Office Action Summary

10/560,365

HIWATA ET AL.

DETAILED ACTION

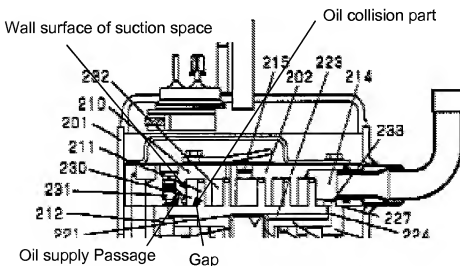
Regarding claim 1, YOSHIYUKI ET AL, FUJIO ET AL, and HIWATA ET AL disclose:

- A scroll compressor (see Figures 1-3 and 5 of YOSHIYUKI ET AL; see Figures 8 and 14 – 17D of FUJIO ET AL; see Figures 1, 4, and 5 of HIWATA ET AL) in

which a fixed scroll part ((10) of YOSHIYUKI ET AL; (7) of FUJIO ET AL; (2) of HIWATA ET AL) and an orbiting scroll part ((11) of YOSHIYUKI ET AL; (13) of FUJIO ET AL; (4) of HIWATA ET AL) are meshed with each other (see Figures 1, 3, and 5 of YOSHIYUKI ET AL; see Figures 8 and 14 – 17D of FUJIO ET AL; see Figures 1, 4, and 5 of HIWATA ET AL) to form a compression chamber (Page 5, ¶0017, see Figures 1, 3, and 5 of YOSHIYUKI ET AL; (2a) of FUJIO ET AL; (5) of HIWATA ET AL), said orbiting scroll part is allowed to orbit in a circular orbit while restraining said orbiting scroll part from rotating by a rotation-restraint mechanism ((12) of YOSHIYUKI ET AL; (27) of FUJIO ET AL; (22) of HIWATA ET AL), a refrigerant is sucked, compressed and discharged while continuously varying a capacity of said compression chamber (Page 5, ¶0017 of YOSHIYUKI ET AL; Column 12, line 29 – Column 13, 50 of FUJIO ET AL; Column 5, line 26 – Column 6, line 33 of HIWATA ET AL), wherein

- an oil supply passage (see Figures 1, 3, and 5 of YOSHIYUKI ET AL, which shows an oil supply passage near (30, 230, and 330) and Page 6, ¶0020, Page 7, ¶ 0037, and Page 3, ¶006; (43) of FUJIO ET AL; (10) of HIWATA ET AL) is formed in a suction space of said fixed scroll part (see Figures 1, 3, and 5 of YOSHIYUKI ET AL and see Page 10, ¶0027; see Figures 8 and 14 – 17D of FUJIO ET AL and Column 13, lines 14 - 33; see Figures 1, 4, and 5 of HIWATA ET AL and Column 5, line 45 – Column 6, line 29, Column 7, lines 19 - 61), and said suction space is provided with an oil collision part (the oil collision part is (11, 211, and 311) of YOSHIYUKI ET AL which is part of the orbiting scroll wrap;

(13a) of FUJIO ET AL in which the oil collision part is part of the orbiting scroll wrap; (4a) of HIWATA ET AL in which the oil collision part is part of the orbiting scroll wrap).

Marked up top half of Figure 3 of YOSHIYUKI ET

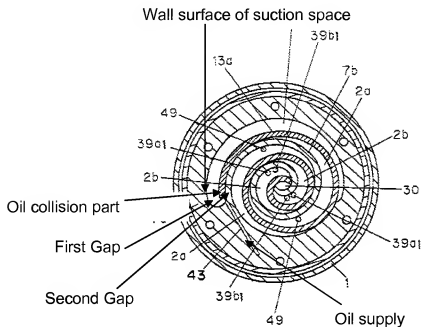
- a gap is formed between said oil collision part and a wall surface of said suction space (see marked up Figure 3 of YOSHIYUKI ET AL below; see marked up Figures 15 and 16 of FUJIO ET AL below; see marked up Figure 4 of HIWATA ET AL below).

Marked up Figure 15 of FUJIO ET AL.

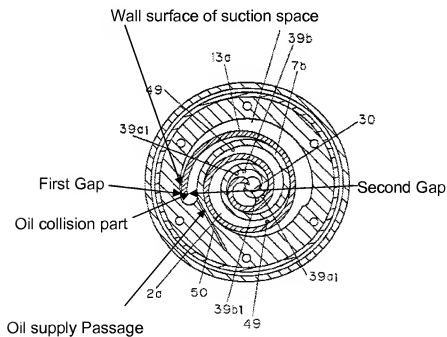
- said gap comprises a first gap (see marked up Figure 15 above) formed from said oil supply passage toward a suction pipe and a second gap (see marked up Figure 15 above) formed from said oil supply passage toward said compression chamber (see marked up Figure 15 above), and said first gap is greater than said second gap (see marked up Figure 15 above).
